AGENDA

PLAN COMMISSION MEETING

Thursday – April 26, 2018 – 7:00 p.m.

STAFF REVIEW COMMENTS
Plan Commission Meeting – Meeting April 26, 2018

SITE PLAN
 1/32" = 1'-0"

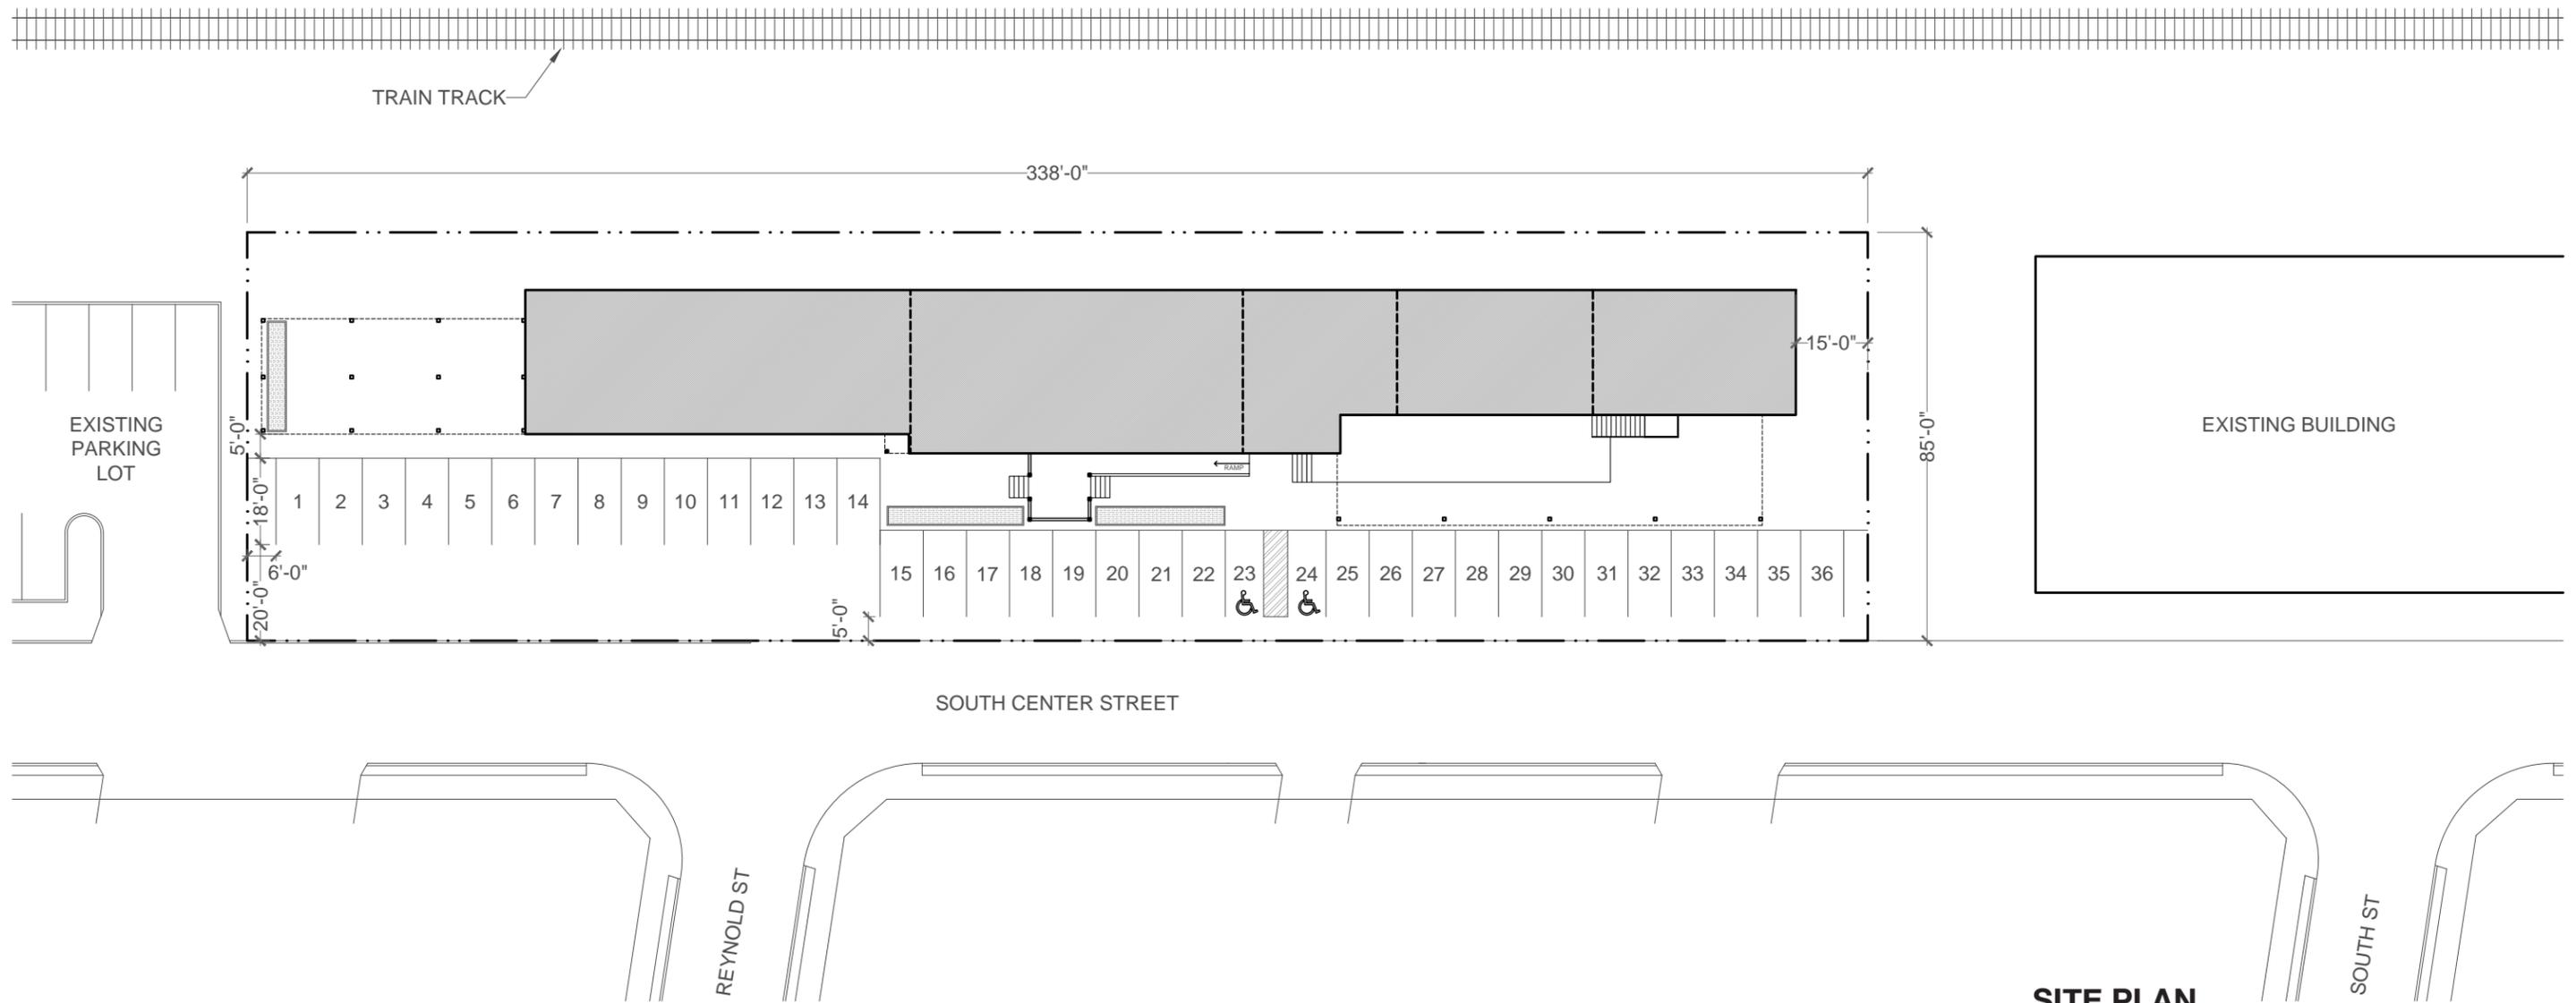
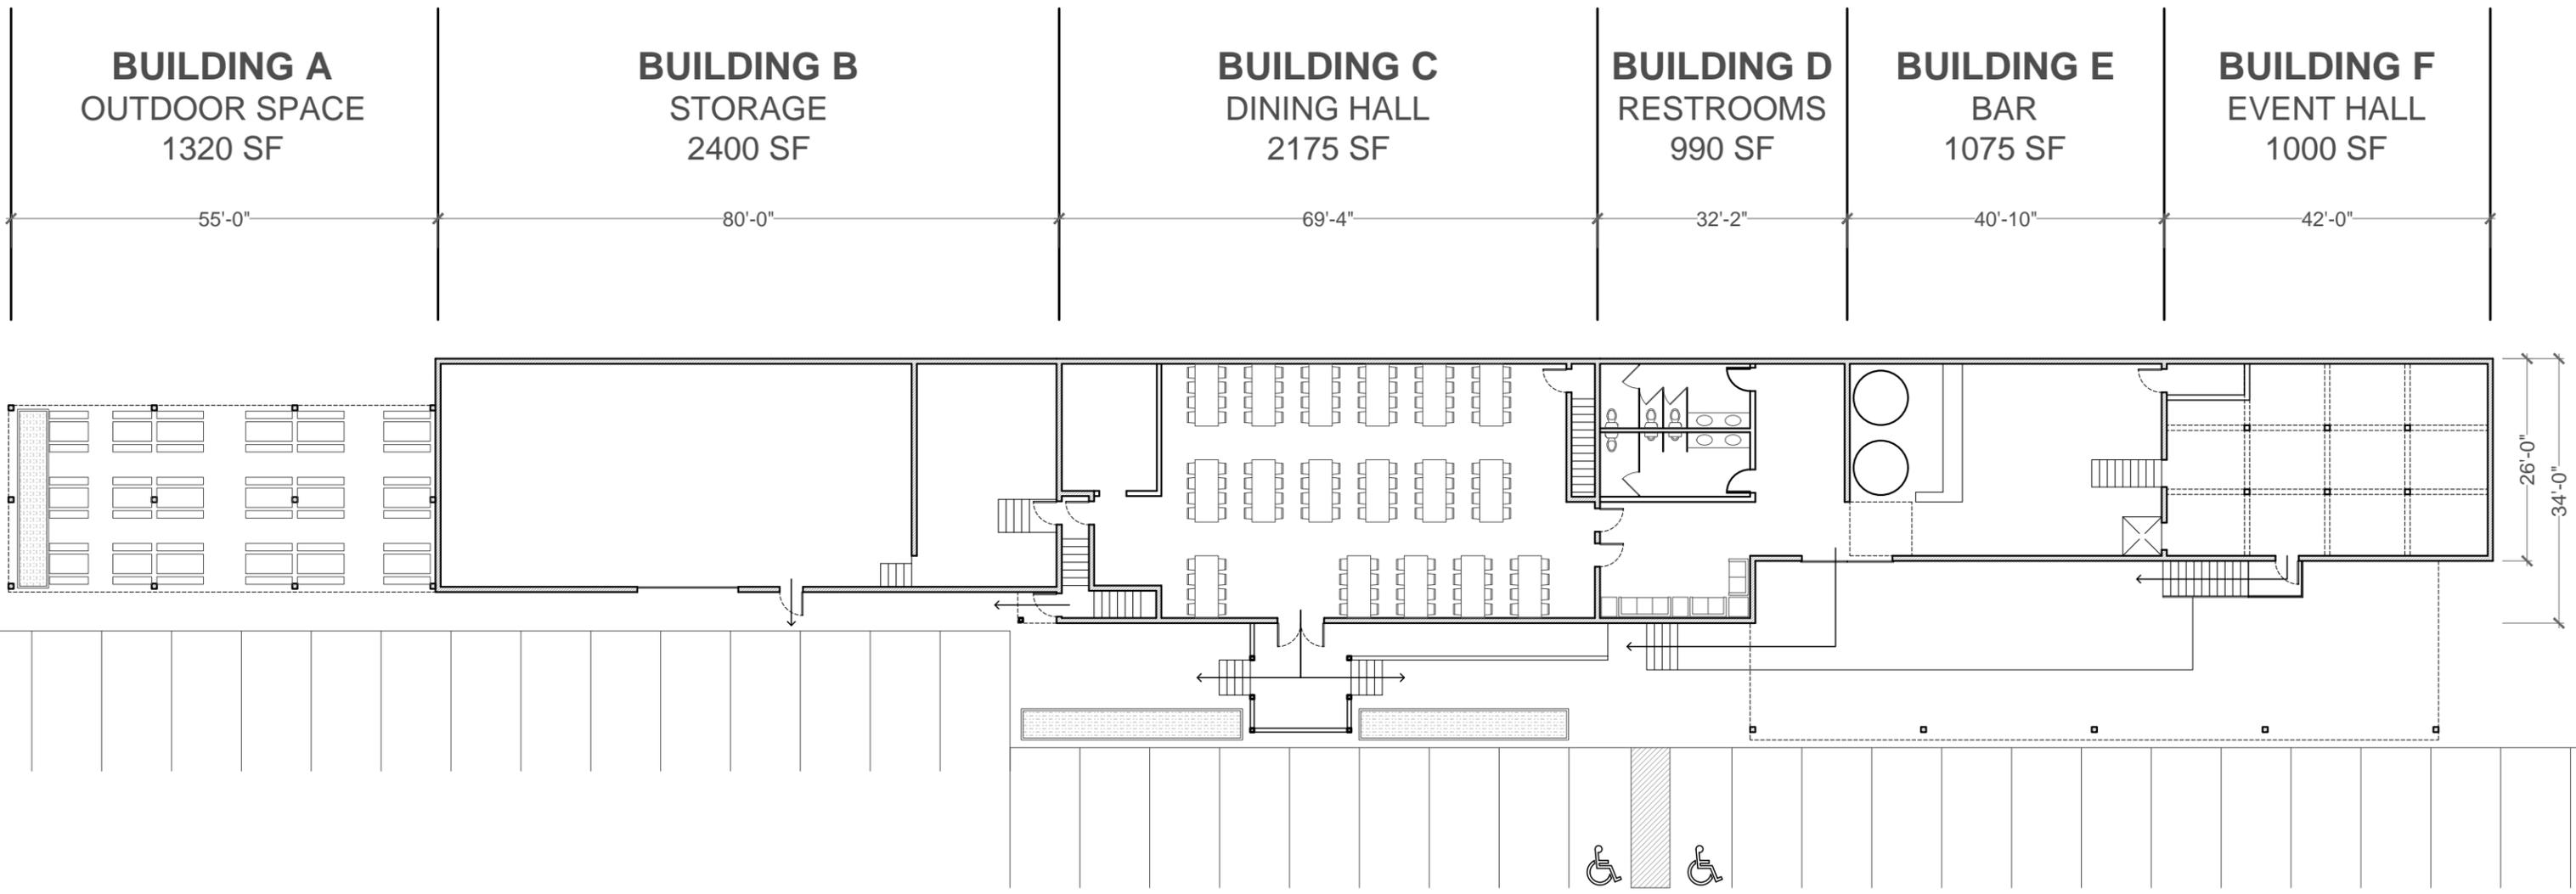
- State of Wisconsin Plan Review is required.
- Sign(s) will be required to be submitted at a future date and will be required to have a separate Plan Commission and Village Board approvals.
- Second accessible ramp shall be required for the raised floor area at the south end of the building space. This also shall exit to grade.
- Due to the building classification as an assembly, firewalls/fire barriers or sprinklers will be required.
- Adequate parking shall be provided for the events that will be hosted.
- Recommend approval. This would be an excellent addition to the village and will greatly improve the appearance and condition of the building.

1 ADDITION PLAN VIEW
SCALE 1/8" = 1'

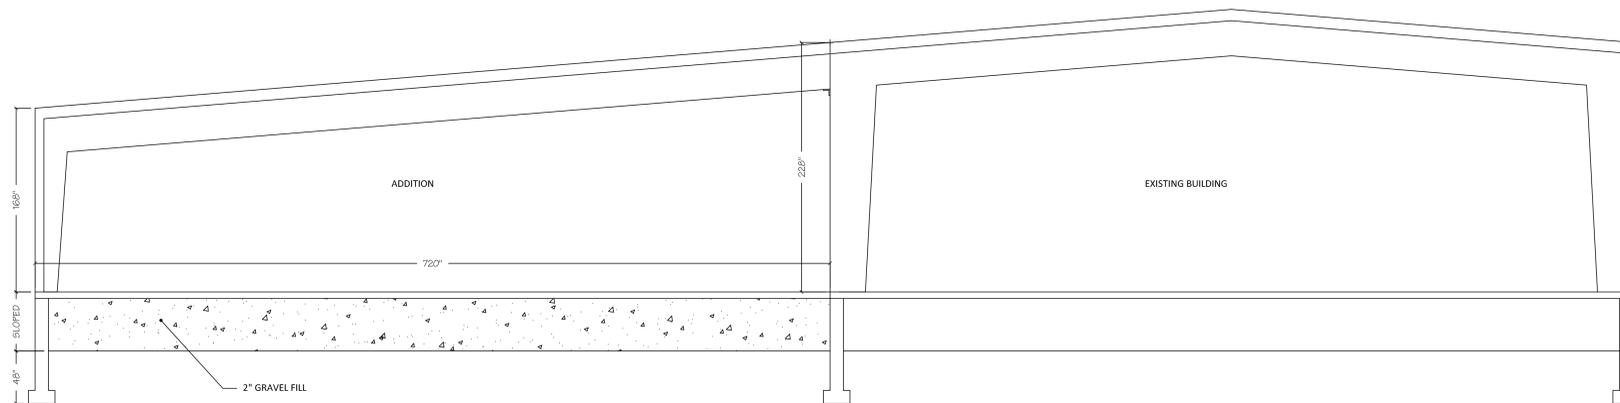
- Due to building size of the addition, a State of Wisconsin Plan Review will be required and plans will need to be drawn up by an Architect/Engineer.
- Addition and out building shall have matching materials and colors that match the existing building.
- Sprinklers shall be installed in new addition and shall be tied into the existing sprinkler system.
- Will bathrooms or water needed at rear storage/out building? Or will this be cold storage.
- Recommend no outdoor storage be permitted
- Recommend approval

FOR: NFI JACKSON, LLC
EXISTING CONDITIONS AND SITE PLAN
COBBLESTONE MEADOWS
PART OF THE SE 1/4 OF SECTION 19, T 10 N, R 20 E,
VILLAGE OF JACKSON, WASHINGTON COUNTY, WISCONSIN

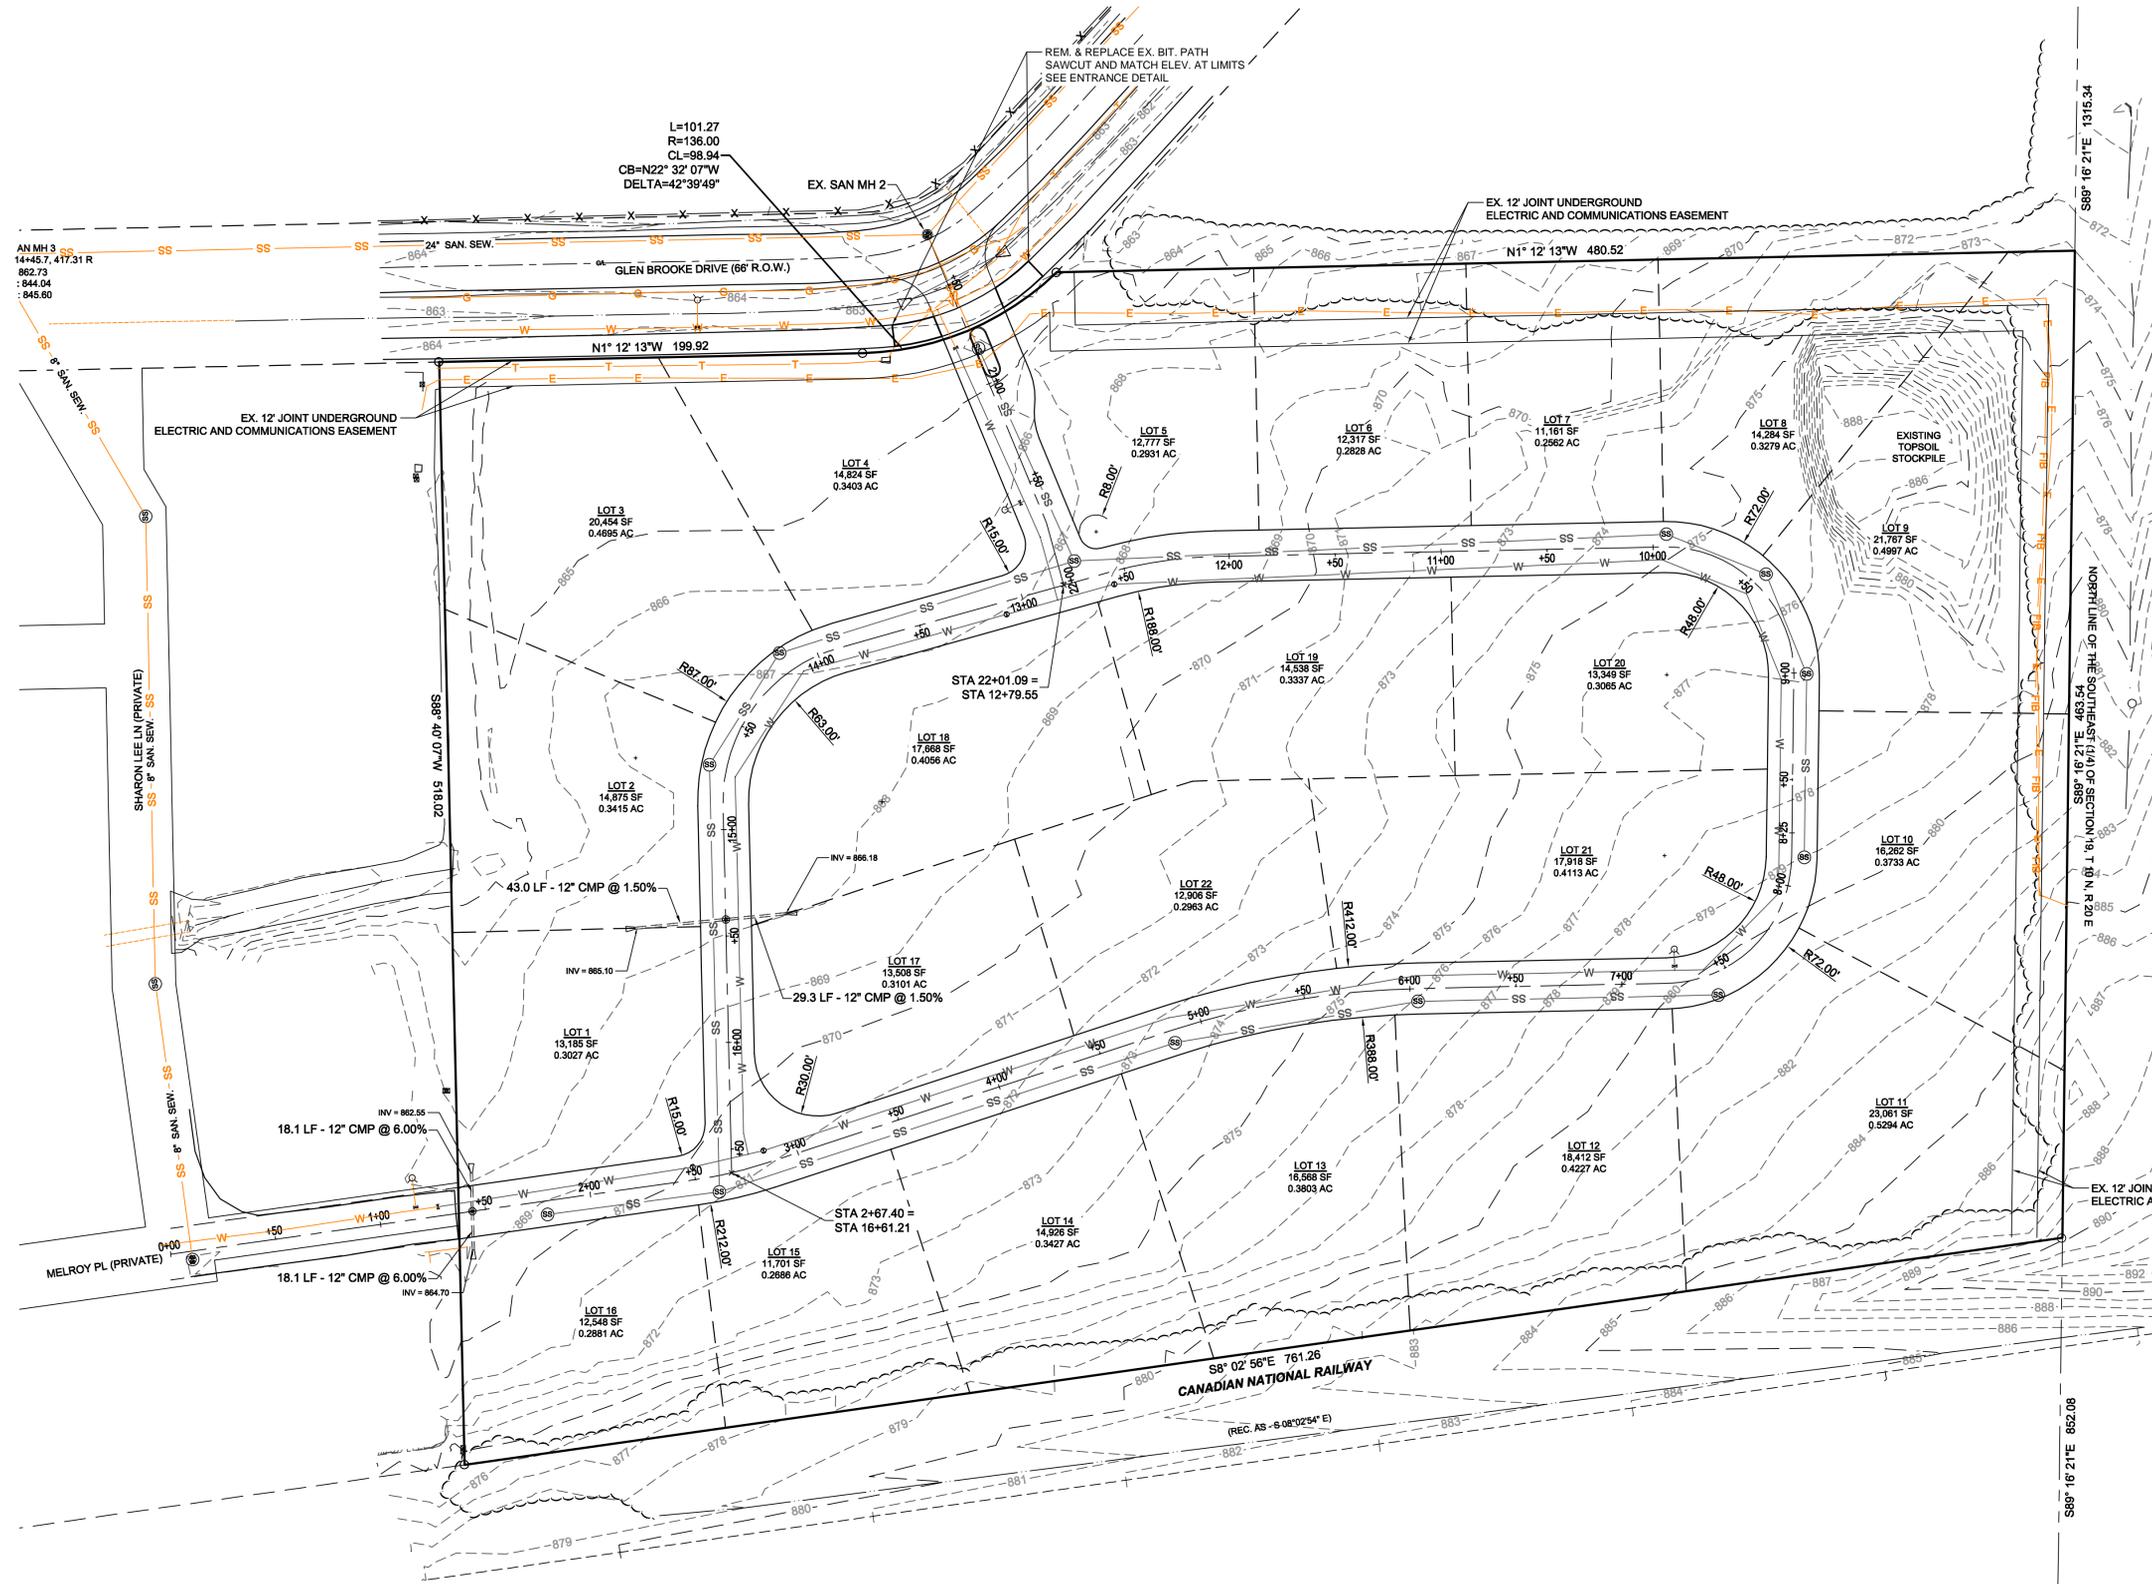
- Layout of lots, streets and proposed setbacks appear to be fine.
- Since there will be no storm sewer, the Inspection Department would like to see all sump pumps discharge directly to a swale that takes the clear water to the drainage easements.
- There was no subdivision sign with this submittal. All future signage shall require Plan Commission and Village Board approvals. This can be submitted at a future date.
- Recommend approval

- The Developer shall provide the Village with the proposed street names.
- The Developer shall provide the Village page two of the Preliminary Plat which is the signing page.
